Addendum No. 1
August 23, 2024

Project: KOA – Rapid City Office
Rapid City, South Dakota
#3017

Architect: Architecture Incorporated

2
4.40 ENLARGED LOWER LEVEL RESTROOMS
SCALE: 1/4" = 1'-0"

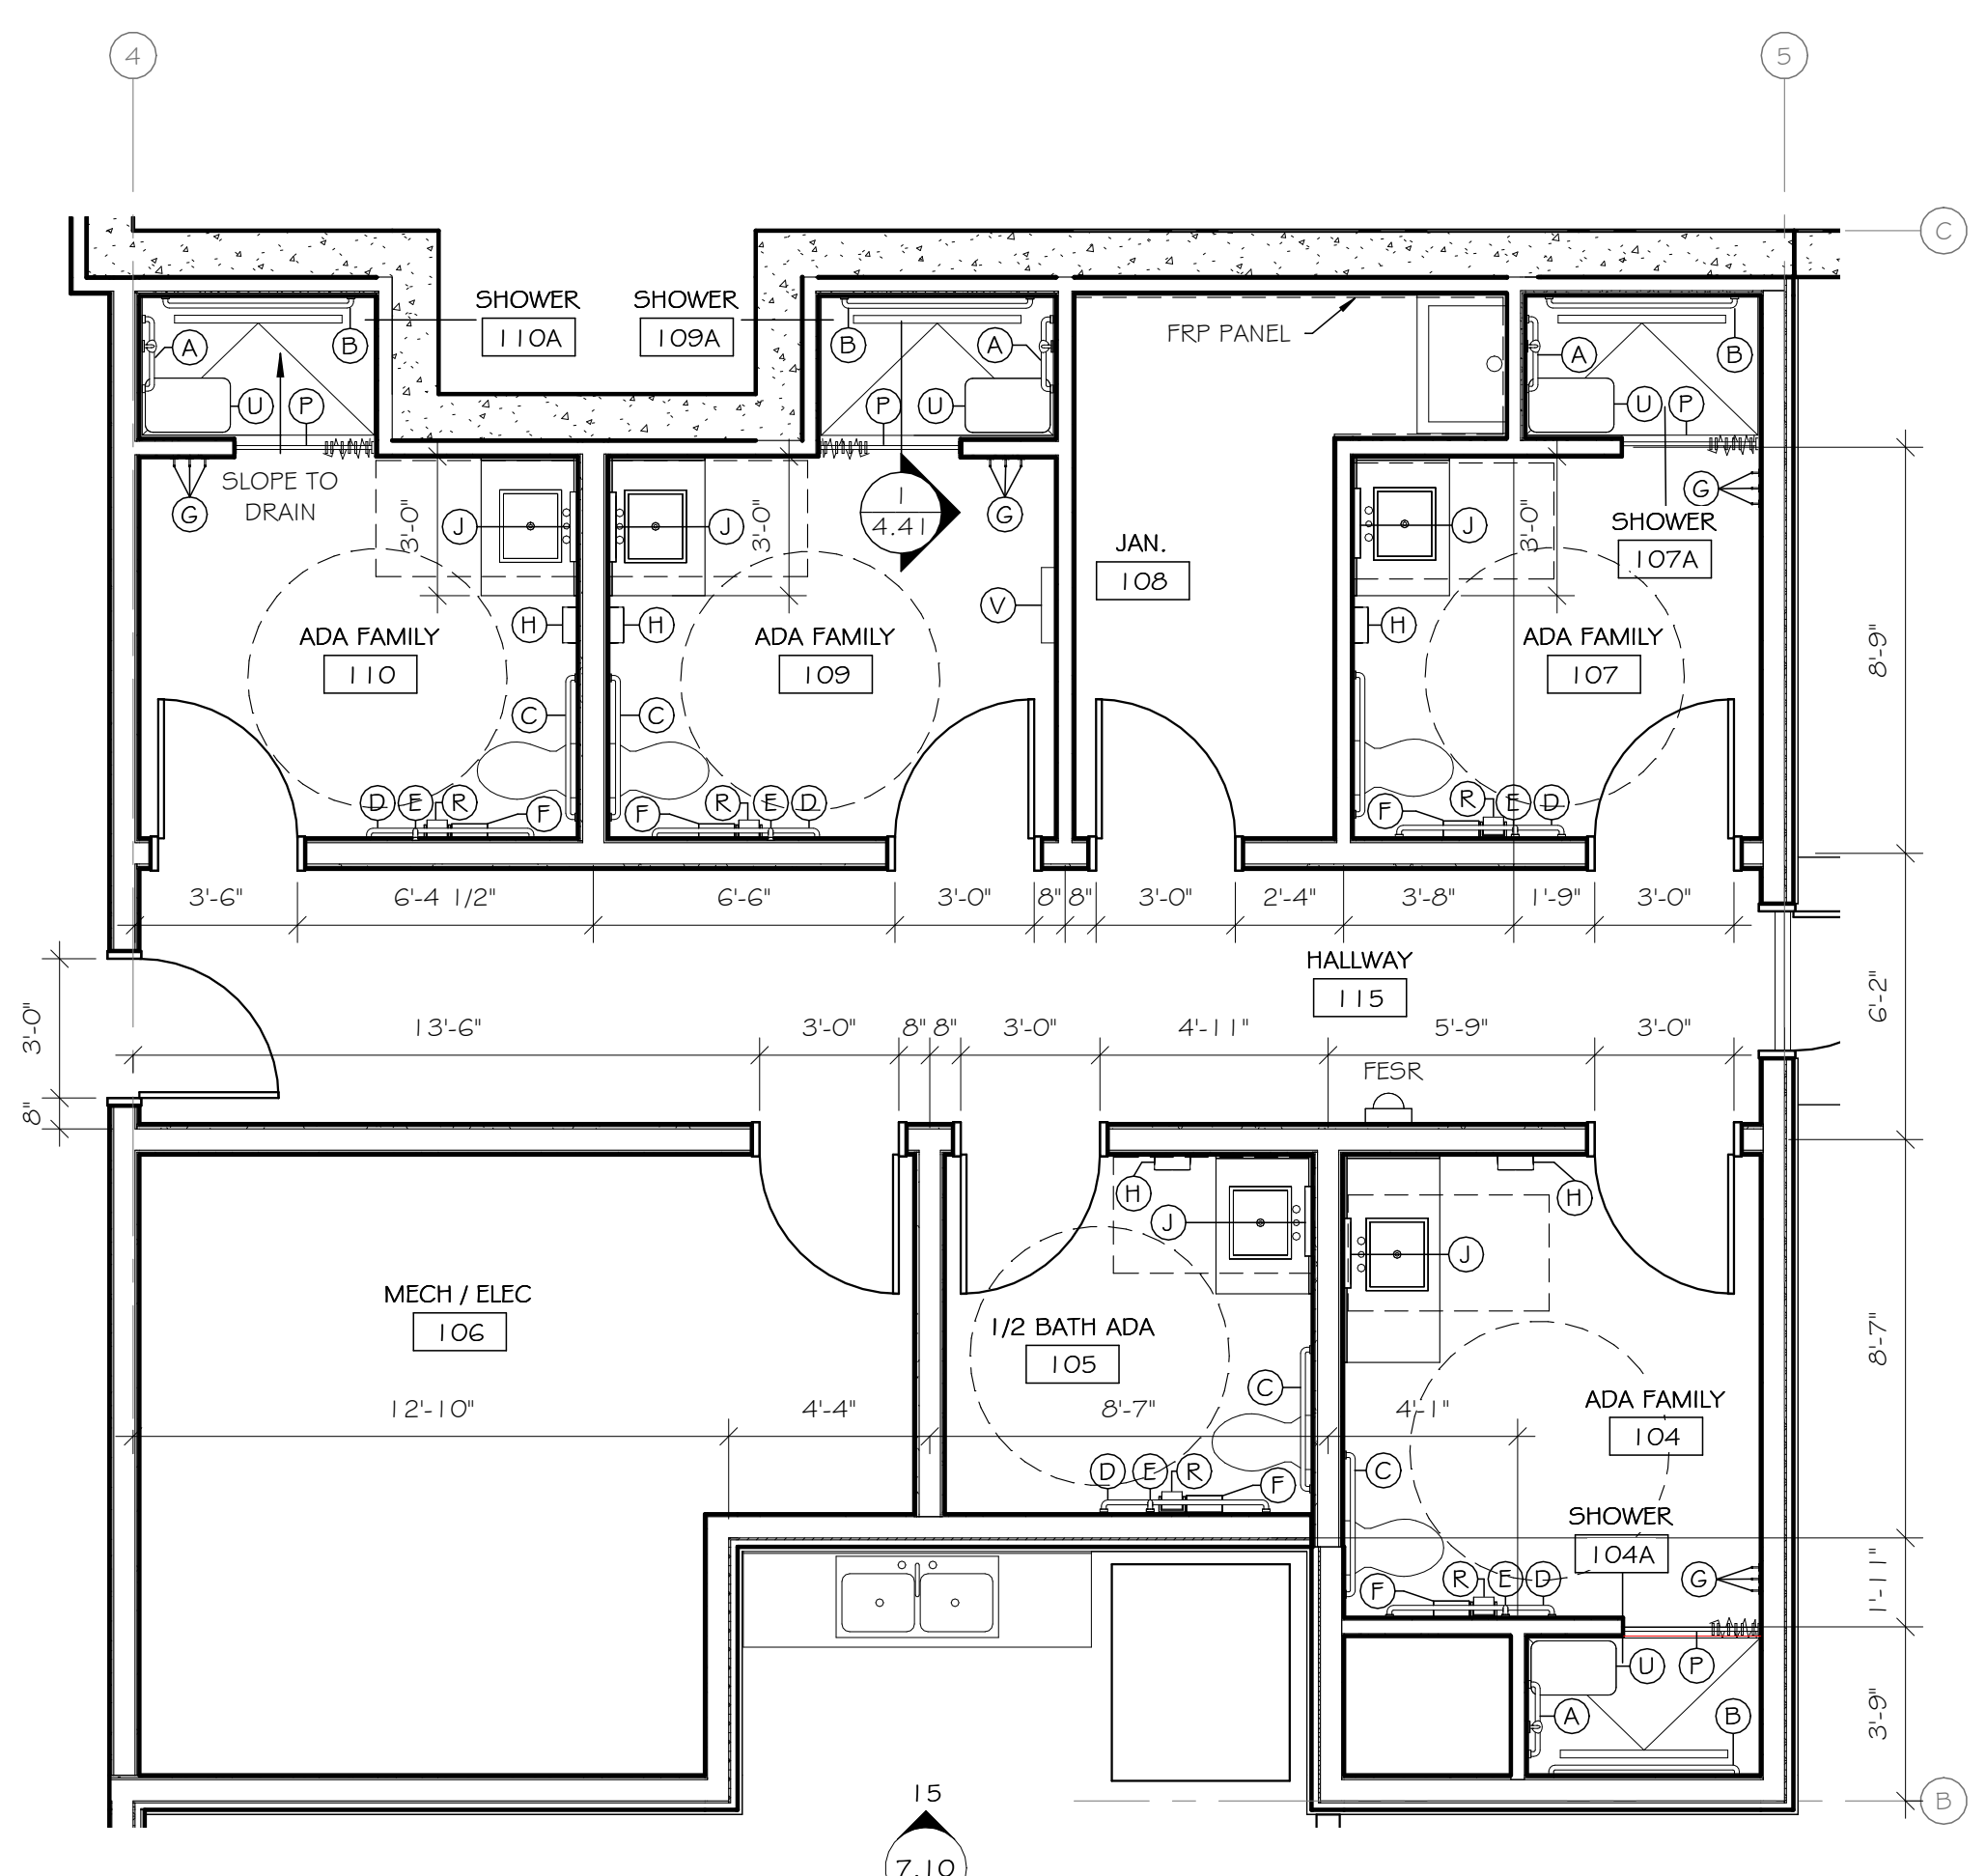
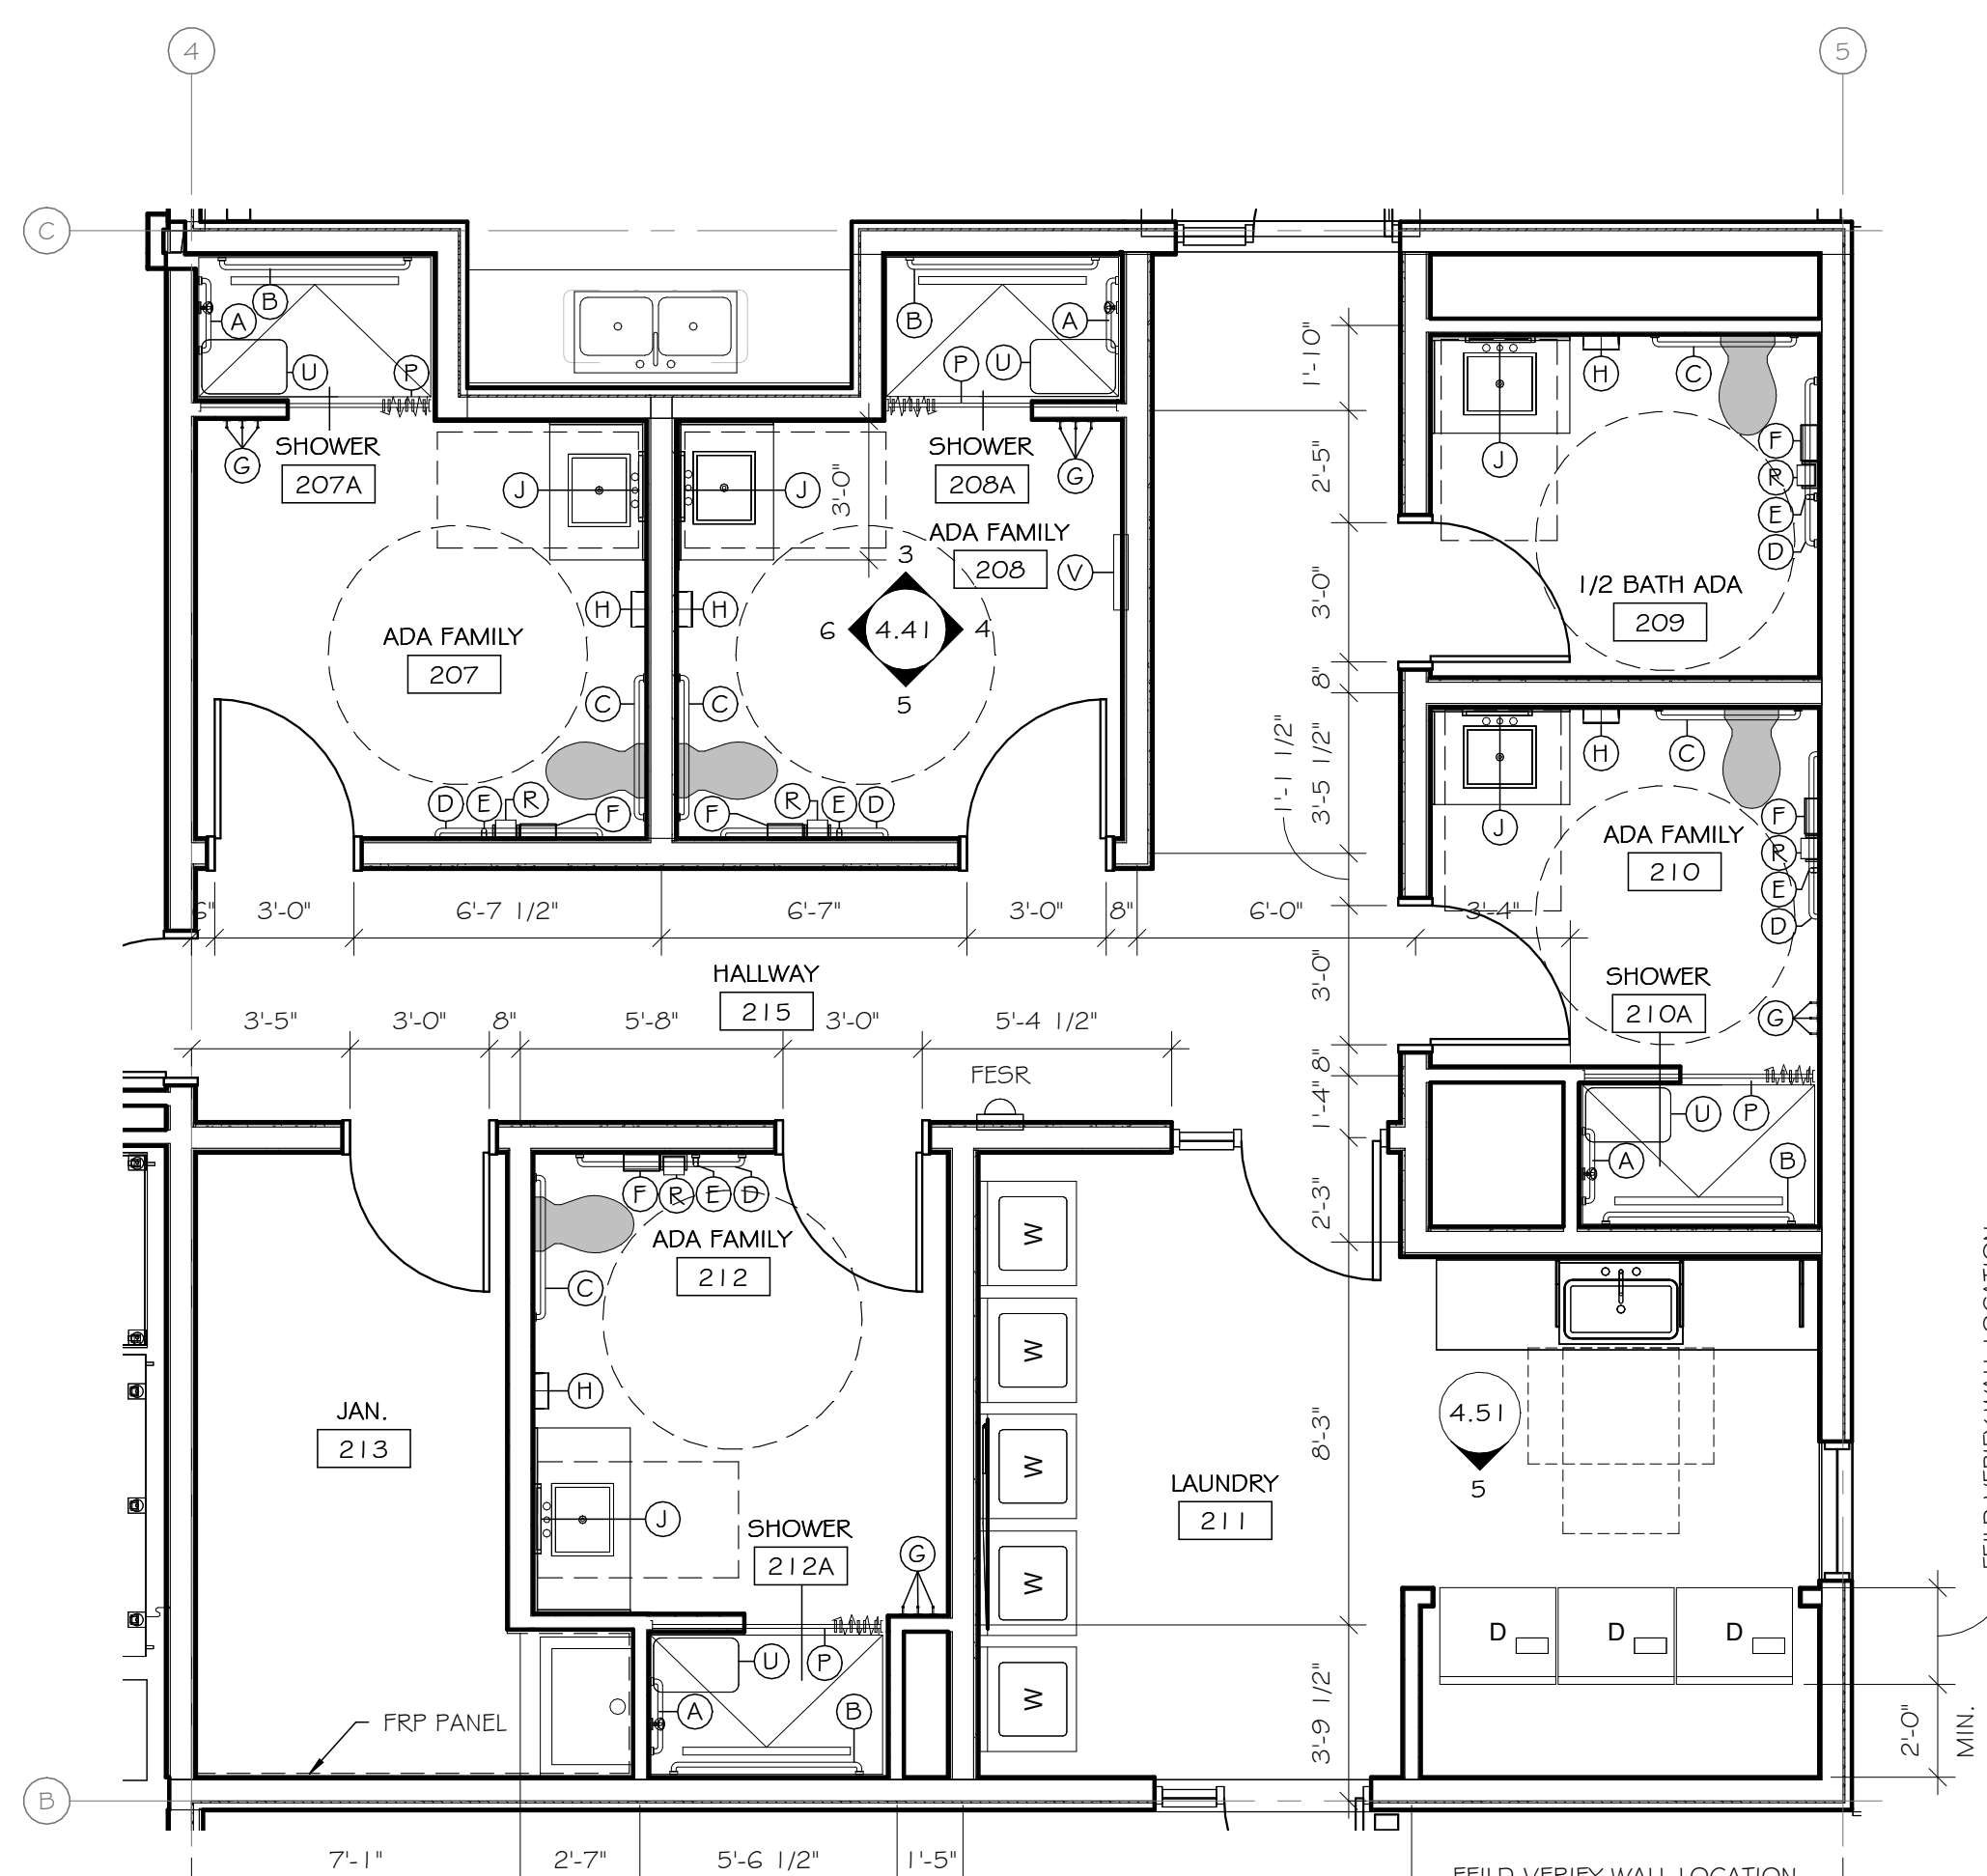
- d) Revised sheet 4.21 is attached, with changes clouded and noted as “1”.
- 10) DRAWING 4.40 –ENLARGED PLANS
- a) Accessory Schedule: Changes in “Notes” column :

- i) Note #6 has been changed to “Contractor Provided, Contractor Installed” and affected accessory items A, B, C, D, E, F, G, H, J, U, & V have been noted accordingly.

- ii) Note #7 has been changed to “See Electrical Drawings” and Hand Dryer “H” has been noted accordingly.
 - iii) Item “R” Toilet Paper Dispenser” has been revised to include Note #5 “Owner Provided, Contractor Installed”.

- iv) Item “V” Babychanging Station” revised to include Note #9 – “Refer to Manufacturer’s Installation Instructions”.
 - b) Detail 3 / 4.40 Enlarged Kitchen Plan: L-shape work Table note revised to clarify that the top is to be L-shape seamless construction.

- c) Revised sheet 4.40 is attached, with changes clouded and noted as “1”.
